TECHNICAL BULLETIN

ELECTRICAL MODIFICATION, LED STROBE

MD900 helicopters, serial numbers 900-000008 thru 900-000139.

ELECTRICAL MODIFICATION, LED STROBE

Figure 1.

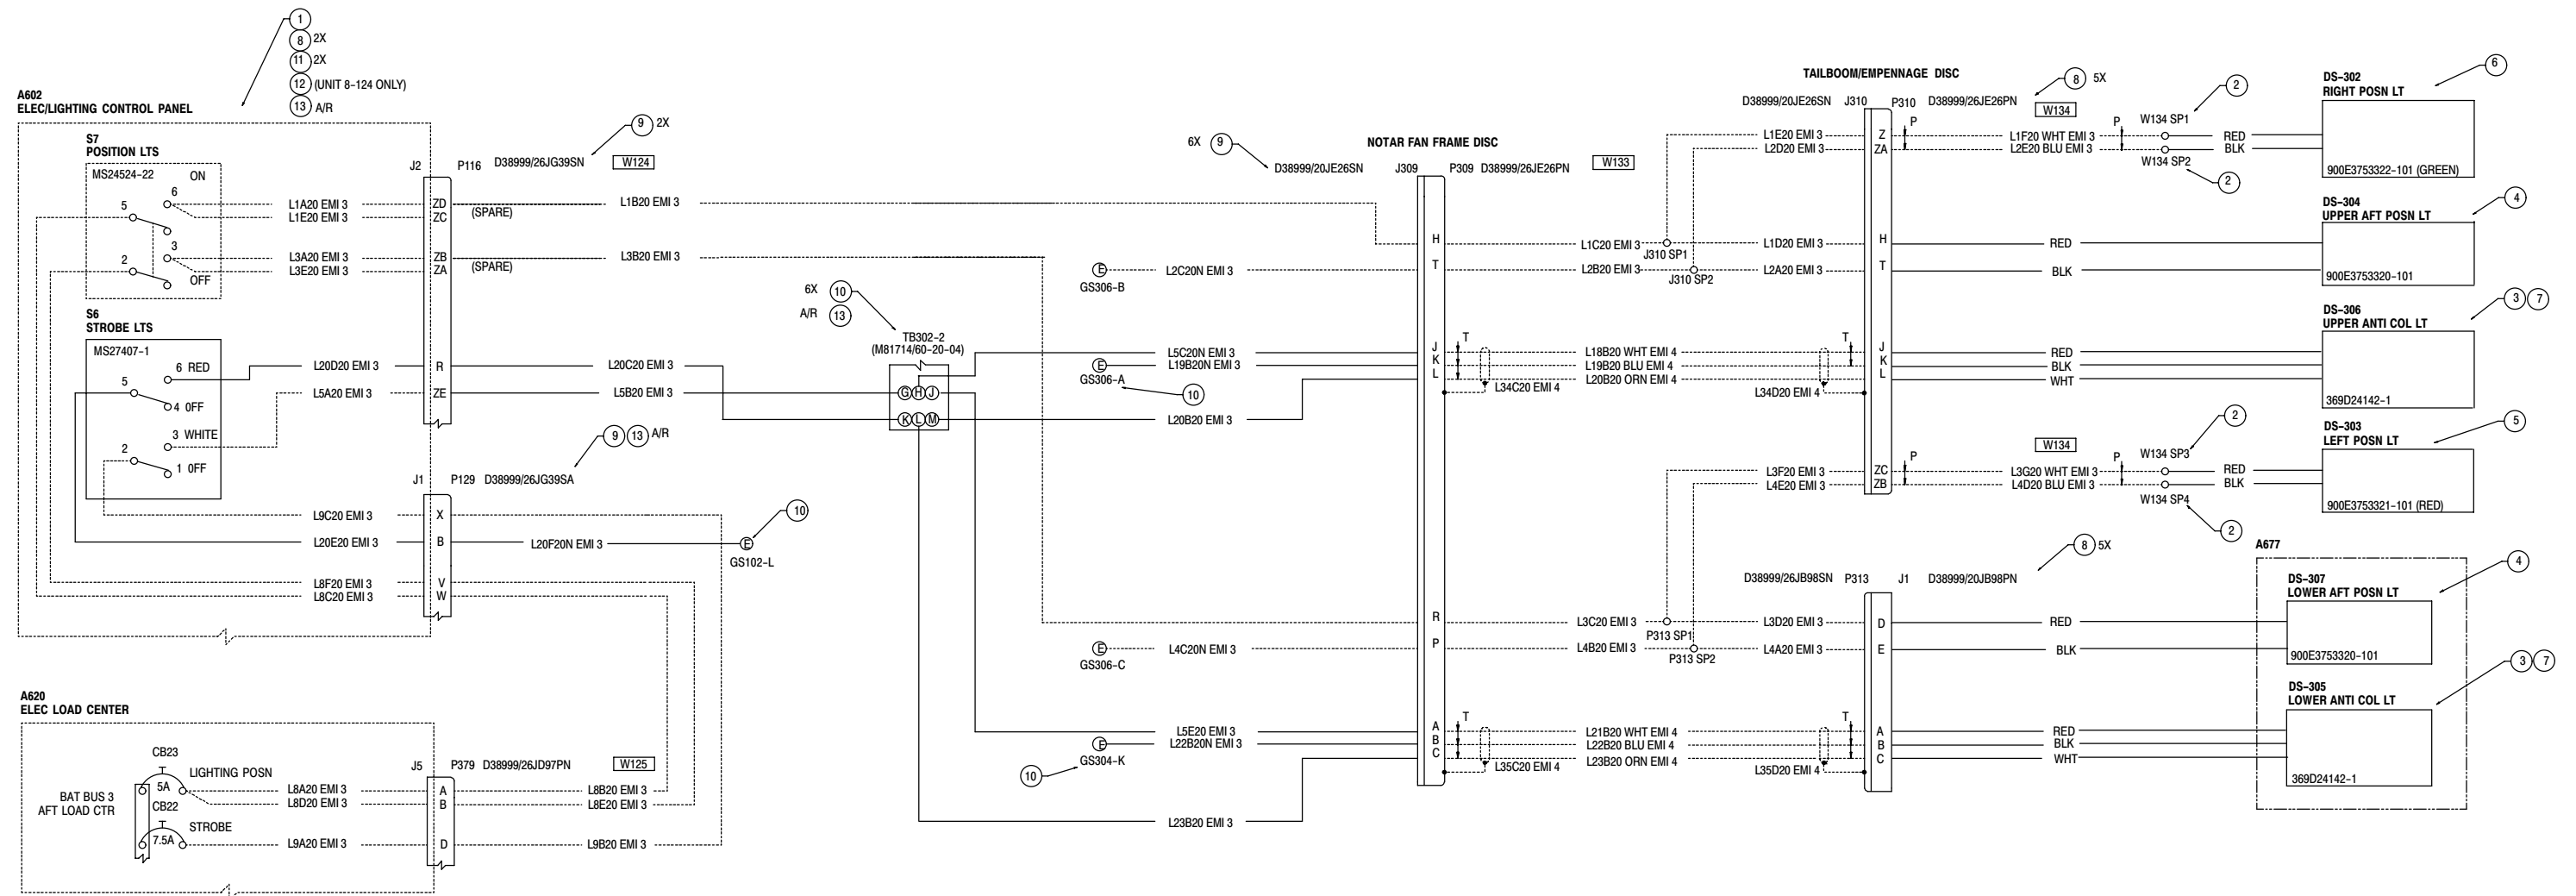
- (d). Terminate Wires At W134 P310 And A677 J1 Per Figure 1.
 - 1). Route wire from navigation lights to termination points. (Ref CSP-SPM, Section 20-60-00).
 - 2). Terminate navigation wires.
 - 3). Dress wires to prevent chaffing.
